**BOUNTIFUL CITY
PLANNING COMMISSION AGENDA
TUESDAY, AUGUST 4, 2026
6:30 P.M.**

Subject: Final Architectural and Site Plan Approval for Bountiful Library Remodel at 725 South Main Street

Bountiful Library Addendum No. 4 Civil Site Plan Revisions

The following is a list of the Bountiful City comments from their 7/14/26 review and how each was addressed on the civil site plan package.

DEMOLITION PLAN

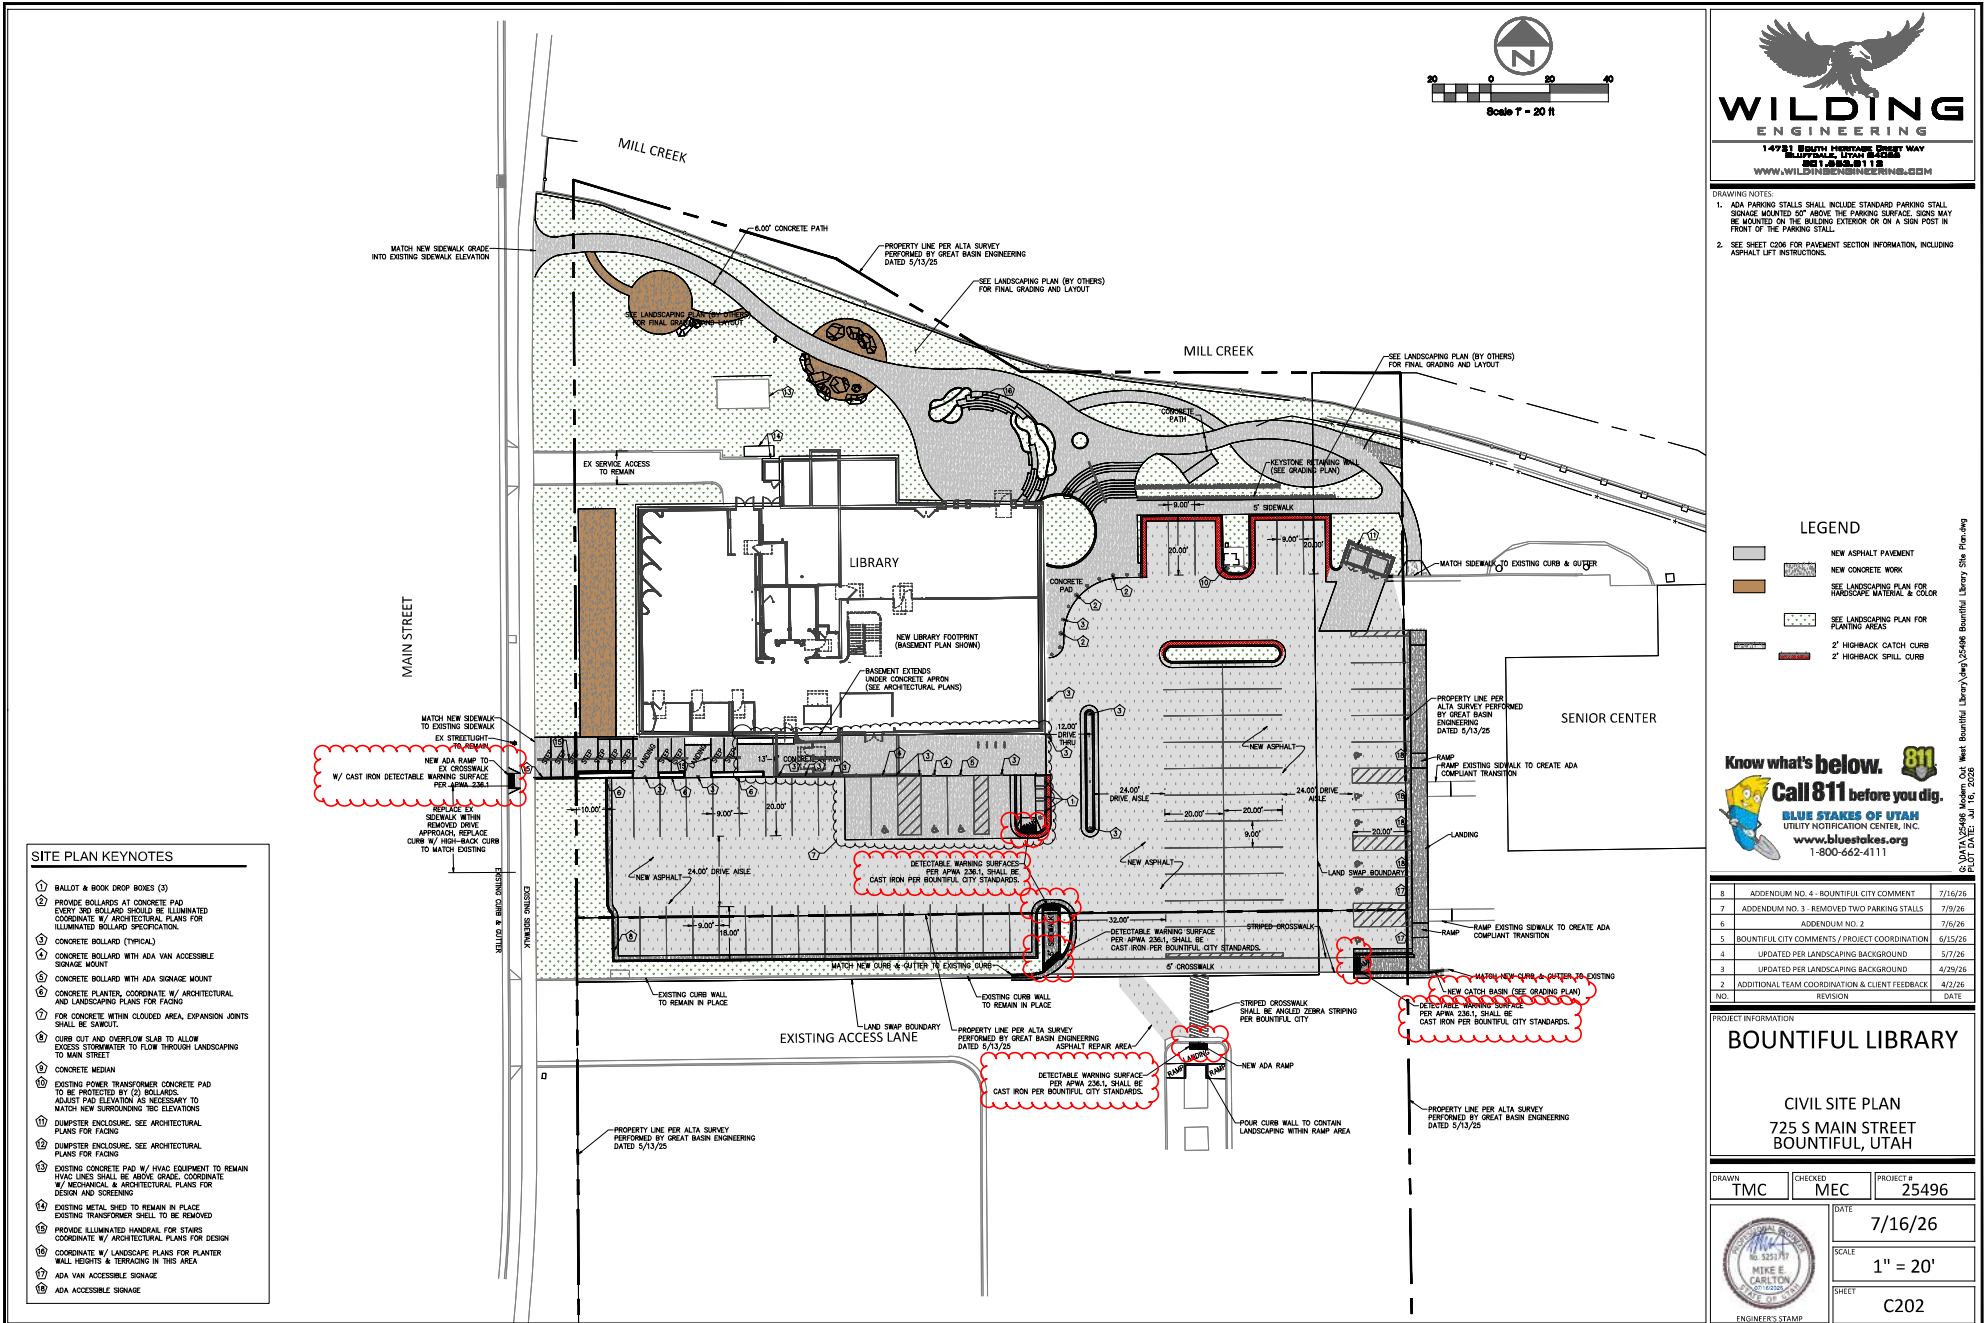
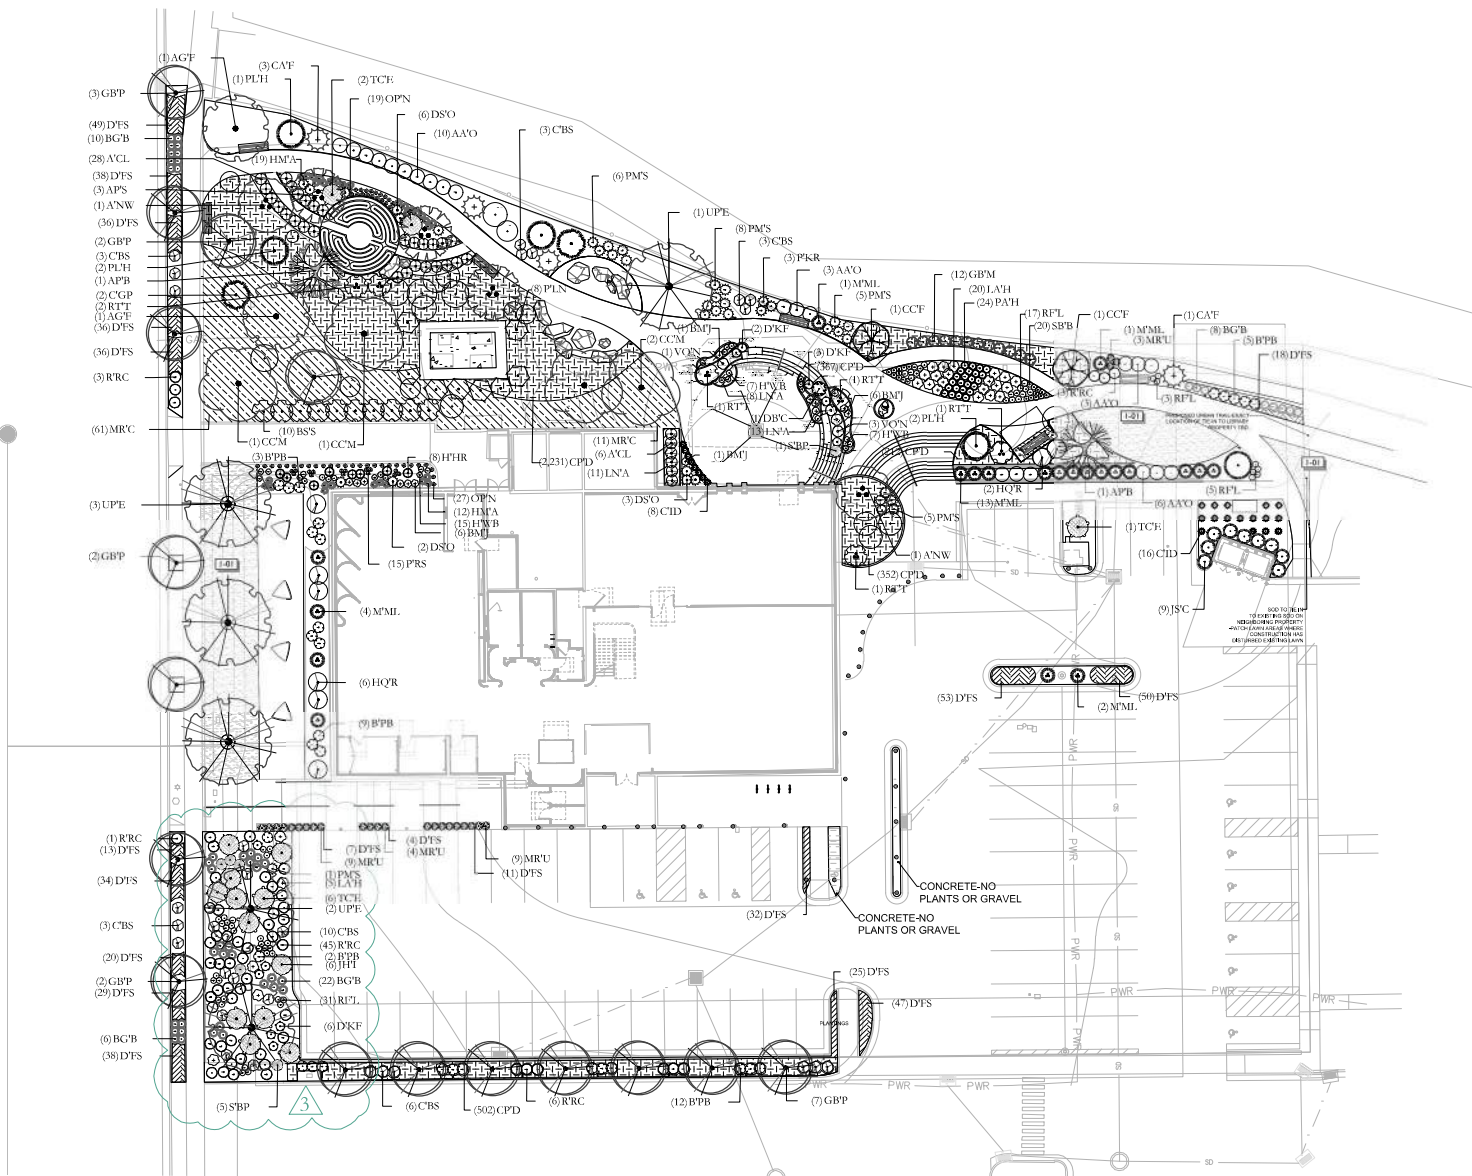
8	ADDENDUM NO. 4 - BOUNTIFUL CITY COMMENT	7/16/25
7	ADDENDUM NO. 3 - REMOVED TWO PARKING STALLS	7/9/26
6	ADDENDUM NO. 2	7/9/26
5	BOUNTIFUL CITY COMMENTS / PROJECT COORDINATION	6/15/26
4	UPDATED PER LANDSCAPING BACKGROUND	5/17/26
3	UPDATED PER LANDSCAPING BACKGROUND	4/29/25
2	ADDITIONAL TEAM COORDINATION & CLIENT FEEDBACK	4/2/26
NO.	REVISION	DATE
